WEST OXFORDSHIRE DRAFT LOCAL PLAN (2012)

LANDSCAPE AND VISUAL REVIEW OF SUBMISSIONS FOR CARTERTON AND WITNEY STRATEGIC DEVELOPMENT OPTIONS

October 2012

FIGURE 1A: CARTERTON

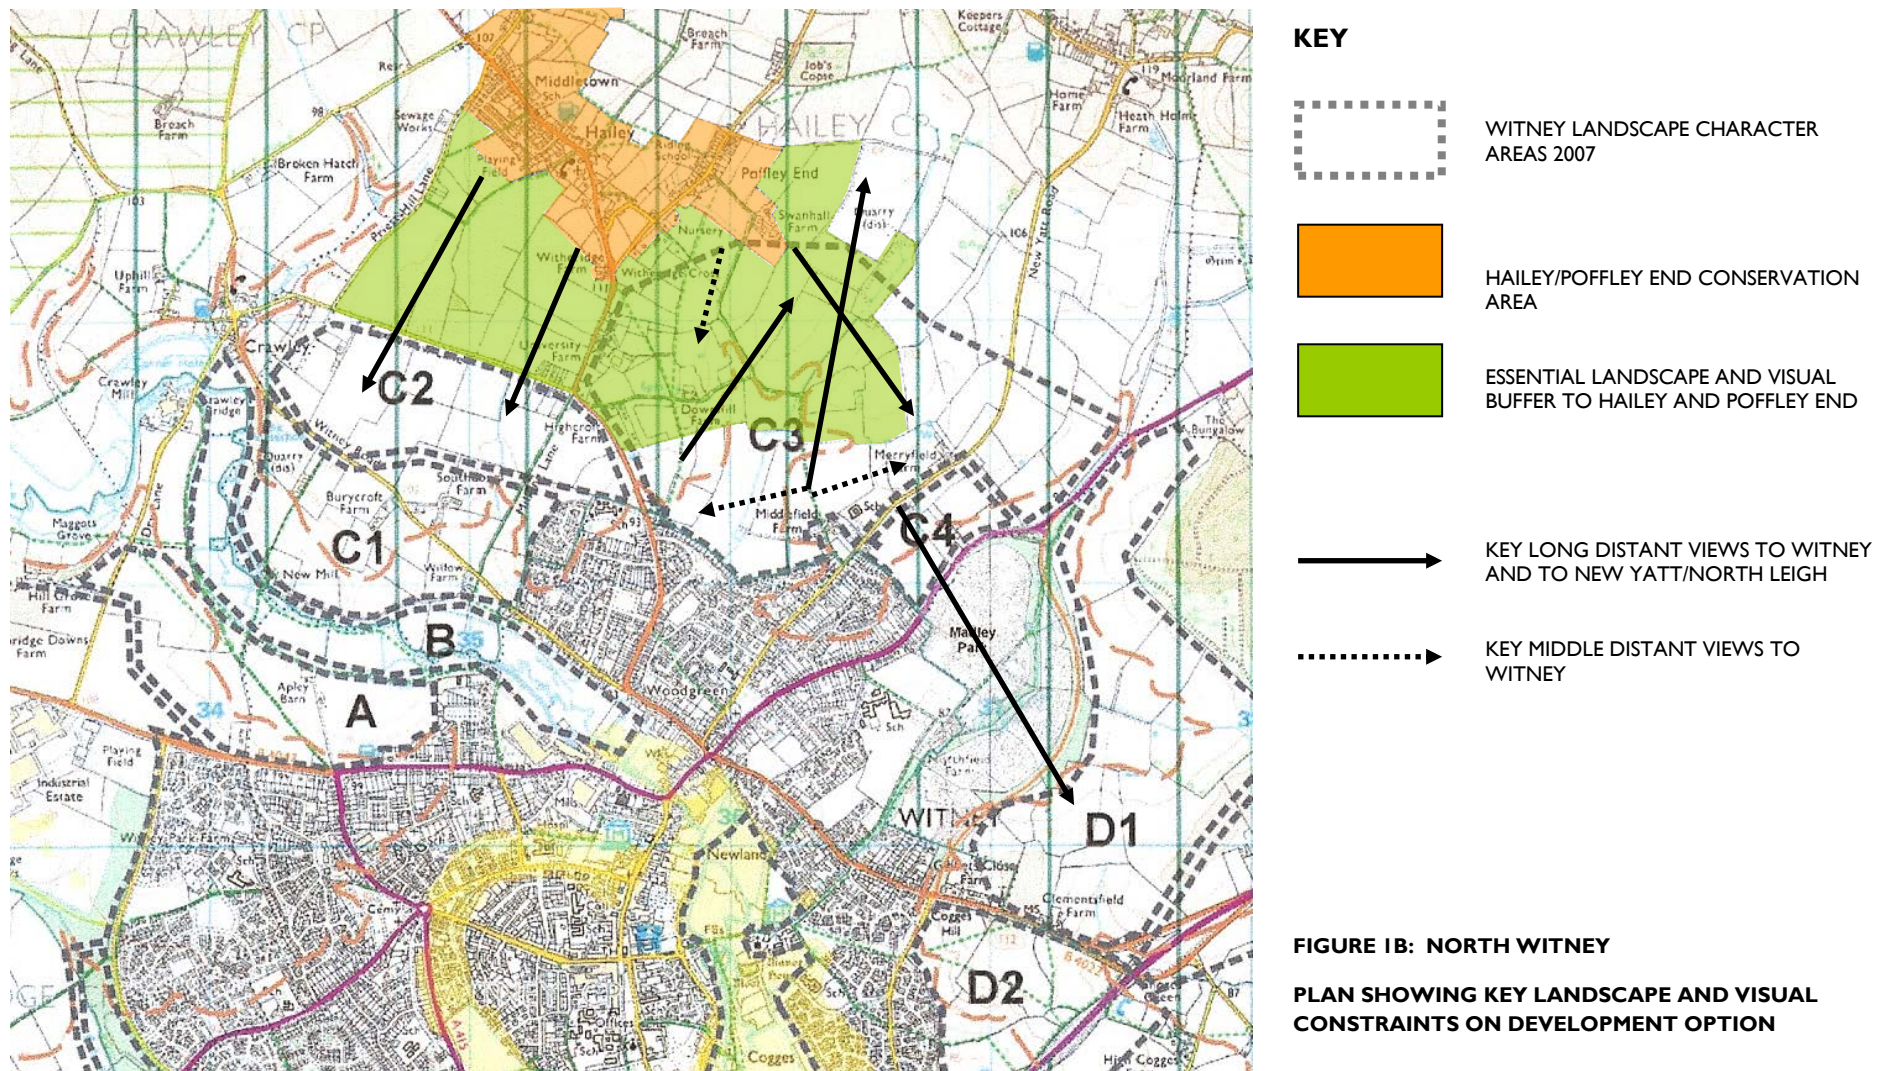
- Provide a landscape transition zone between the site and Brize Norton to protect the character of the village and its landscape setting as shown in Figure 1A. Detailed landscape analysis should be used to determine the final width;

Landscape setting of Brize Norton	South-east corner falls within landscape buffer to Brize Norton – see Figure 1A	The most south easterly portion of the development intrudes into this gap	The very small open space is inadequate to maintain the separation of Brize Norton and Carterton	Any development should include an extension to the green infrastructure of the park within the landscape transition zone

FIGURE 2B: NORTH WITNEY

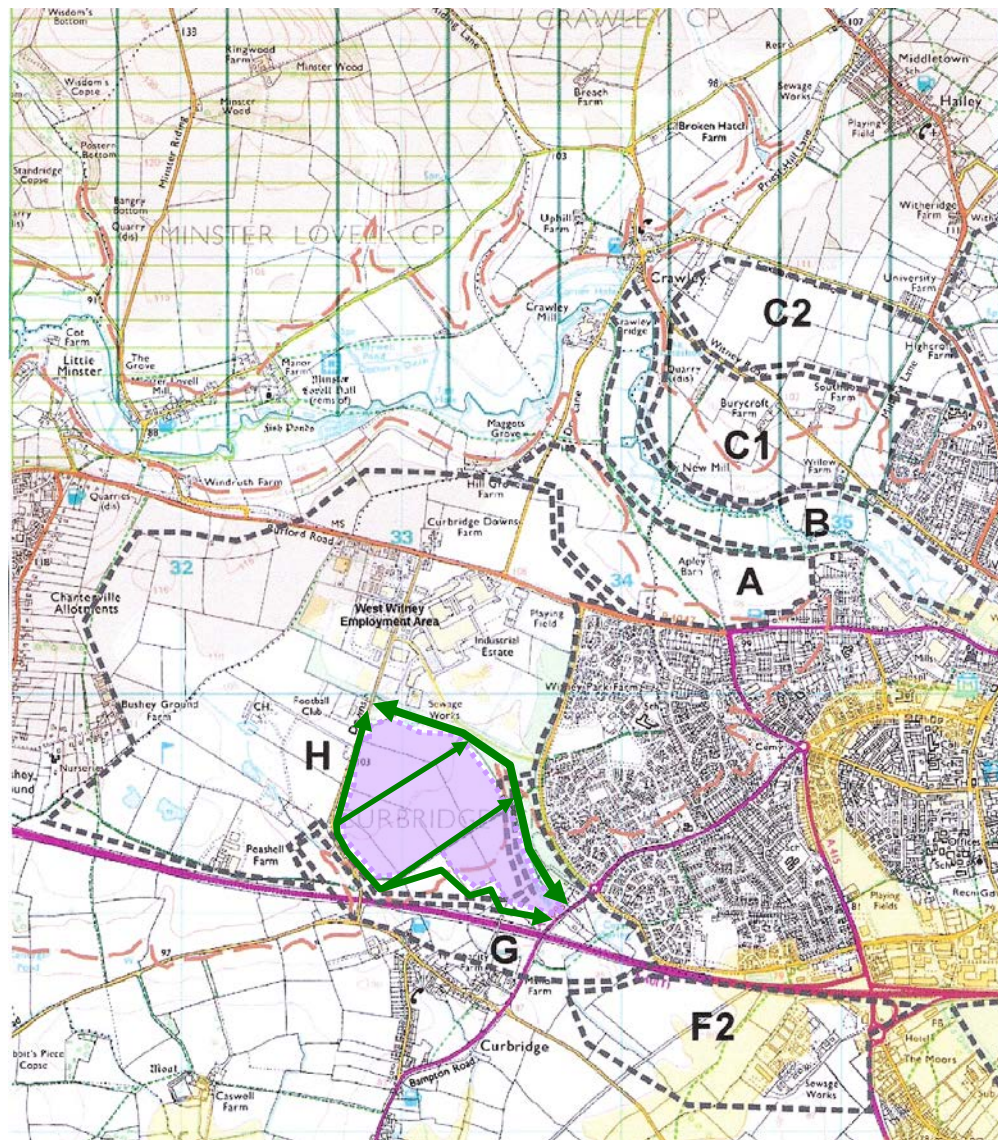
This report concludes that, provided a substantive landscape transition zone is retained next to Hailey/Poffley End as shown in Figure 2B, this option could be developed on smaller scale as an extension to the existing built form. The landscape character is already influenced by the existing urban edge and the site could be partly developed without harm to the wider landscape. A number of recommendations seek to protect and improve the urban edge and local landscape features.

Sense of tranquillity away from urban edge of Witney	Further erosion of tranquillity within Wychwood Project Area	X	Pull development south away from Downhill Farm (see Figure 2B) to protect sense of tranquillity south of Poffley End.
	Individual buildings in wooded skyline (Middlefield Farm and school)	Development north of Middlefield Farm creates urban skyline above 95m AOD contour northwards away from Witney	Landscape buffer retained on slightly higher ground	Reinforce woodland planting to create dominant wooded skyline
C4 North Witney: Plateau	Low intervisibility with wider landscape; and from adjacent road network due to hedgerow and tree cover	Limited visual impact in views from the open countryside	Retained hedgerow helps to conserve low intervisibility	Reinforce visual containment on eastern boundary with woodland planting

- The provision of playing fields could be accommodated on the periphery of the development in the vicinity of Middlefield and Downhill Farms provided the field pattern and provision of major landscape infrastructure is also achieved (see Figure 2B);

The potential area to be considered further is shown in Figure 2B.

FIGURE 2C: WEST WITNEY

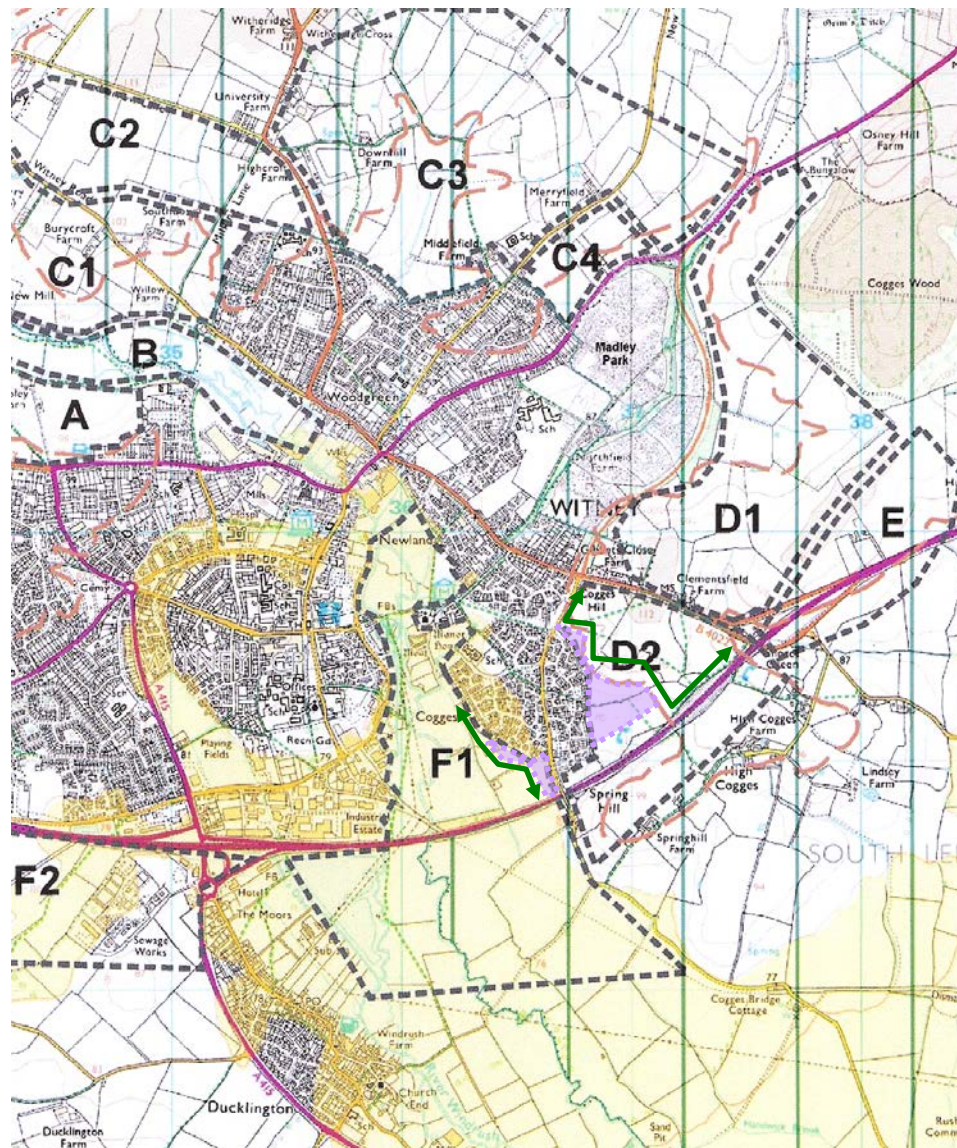
- Frontage development along Downs Road and Curbridge Road as shown in Figure 2C to be designed to enhance the quality and character of the approach to the town, having regard to the adjoining landscape character and key characteristics of the town;

The potential area to be considered further is shown in Figure 2C.
